CENTRAL EL DORADO HILLS SPECIFIC PLAN FINAL ENVIRONMENTAL IMPACT REPORT

October 2019

**ATTACHMENT 5: CENTRAL EL DORADO HILLS
SPECIFIC PLAN DRAFT, RE-CIRCULATED, AND
FINAL ENVIRONMENTAL IMPACT REPORT**

Figure 4. Revised AM Peak Hour Volumes for Cumulative+Project Scenario with Draft EIR Mitigations

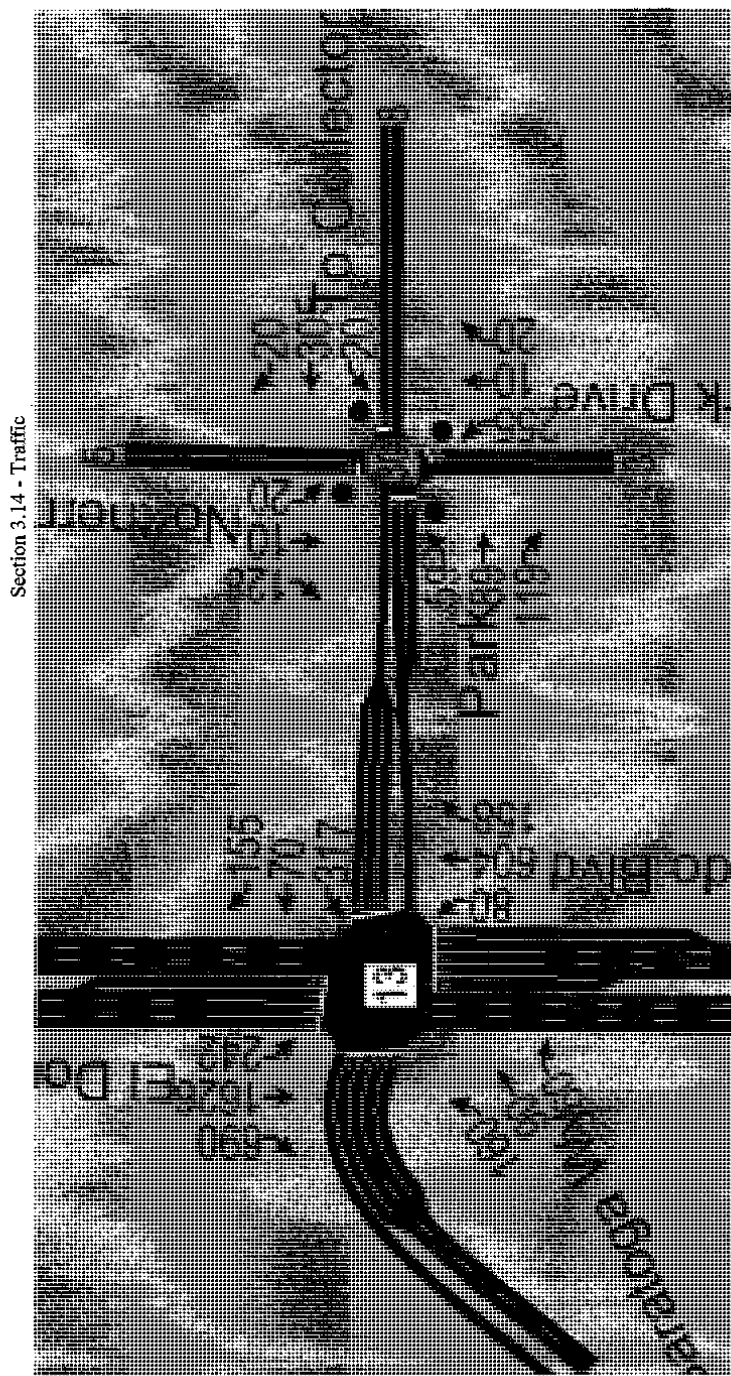
As shown in Table 1, the analysis for unmitigated conditions with adjusted inbound and outbound turning movement volumes results in significant differences compared to the Draft EIR analysis for both Cumulative and Cumulative+Project conditions at the Saratoga Way/Park Drive intersection. Figures 4 and 5 show the revised turning movements with proposed mitigations for AM and PM peak hours, respectively, for the Cumulative+Project scenario.

The commenter notes that there are "significant differences" between his analysis and the analysis in the Draft EIR. The commenter asserts that there will be significant queuing issues and LOS F traffic congestion. Those differences are likely attributable to the commenter's incorrect assumption that the southern intersection would be closed to traffic. As shown in Figure 10B of the Transportation Impact Analysis (Appendix L of the Draft EIR), the southern access point to the shopping center is projected to serve 510 AM peak hour trips (270 inbound, 240 outbound) and 620 trips in the PM peak hour (370 inbound and 250 outbound). The northern access point to the shopping center is projected to serve 570 trips in the AM peak hour and 870 trips in the PM peak hour. Therefore, the southern access point is expected to serve 44% of the traffic accessing the shopping center under the Cumulative Plus Project scenario. The commenter's incorrect assumption shifted a substantial portion of traffic to the northern access point, which led to false conclusions about the projected queuing and traffic operations at that location. All analysis and conclusions that are based on this assumption are also incorrect. This includes the comments about traffic operations and queuing internal to the shopping center and at the intersections along El Dorado Hills Boulevard between US 50 and Serrano Parkway.

Figure 6. Lane Configurations for Cumulative+Project Scenario with Draft EIR Mitigation

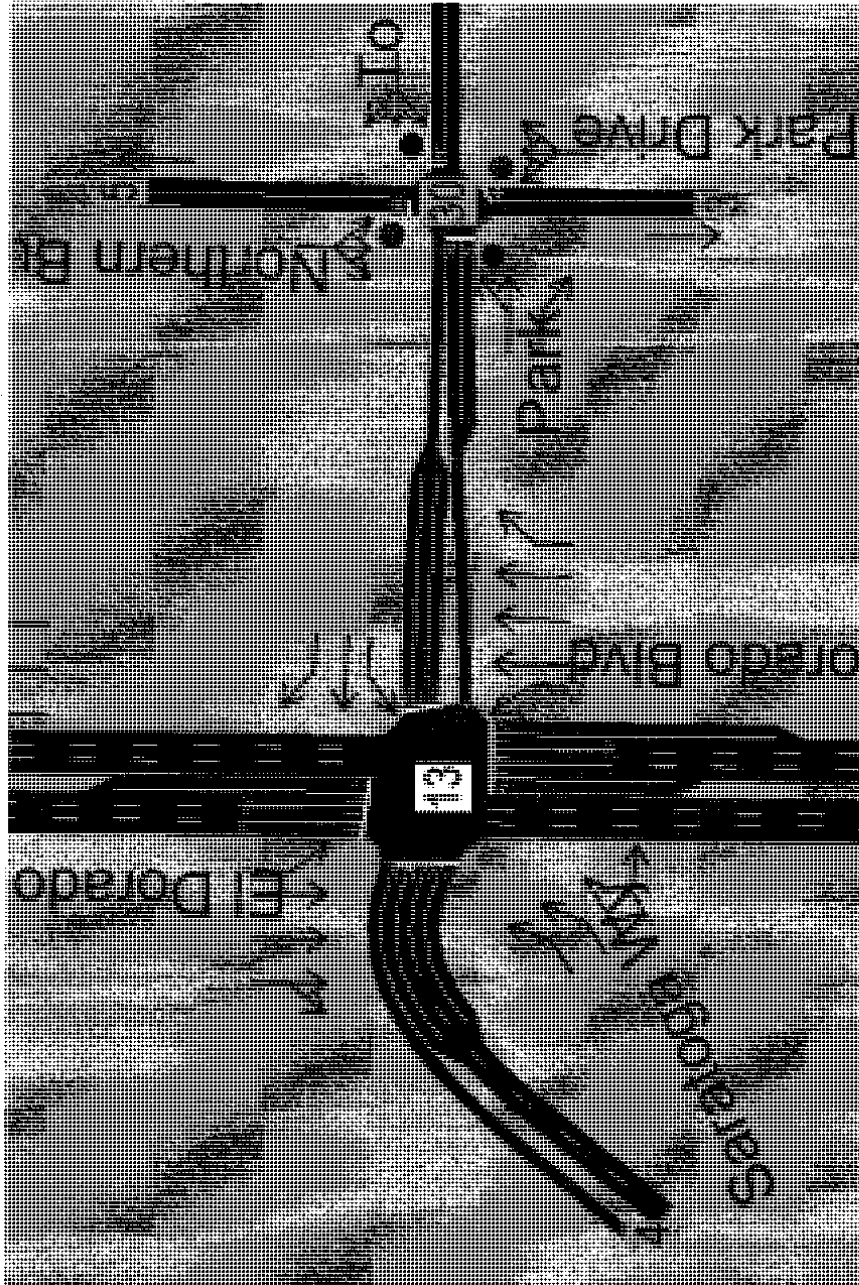
The Draft EIR contains text descriptions of mitigations for the Cumulative+Project scenario designed to reduce impacts to a less than significant level and are as follows and shown in Figure 6: I-11-80 cont.

Figure 8. Key Features of Access Roadway for Project Development between Serrano Parkway and I-50

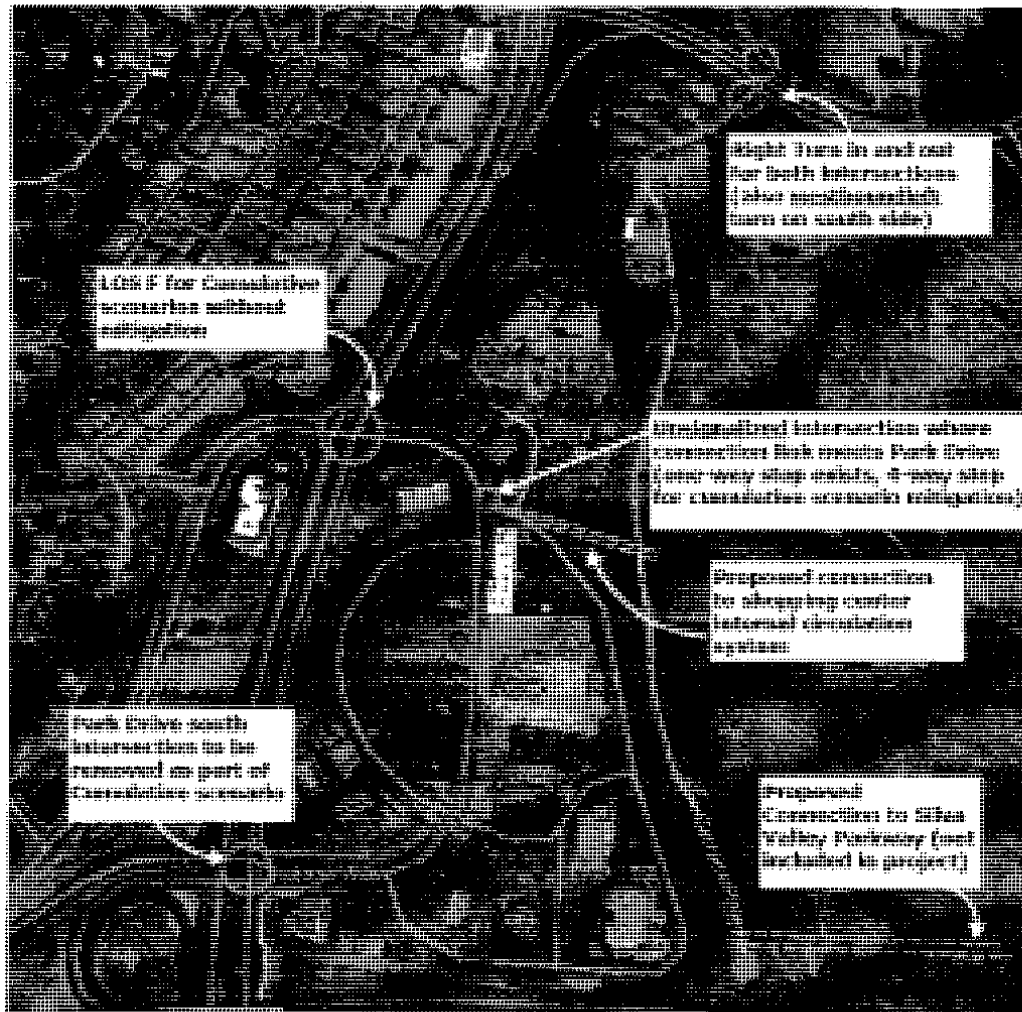
Figure 8 shows the major elements of the proposed circulation system related to the project development to the south of Serrano Parkway, which is the primary focus of my traffic review.

I-11-76: The commenter is concerned with the internal circulation system of the shopping center and the adequacy of the proposed access road to accommodate project traffic. The final design of the access road and intersections would require conformance with County standards. Additionally, the revision to the shopping center, illustrated in Figure 2.10 of the Draft EIR, would require a discretionary design review of the proposed changes. See additional analysis in Response to Comment **I-11-72**.
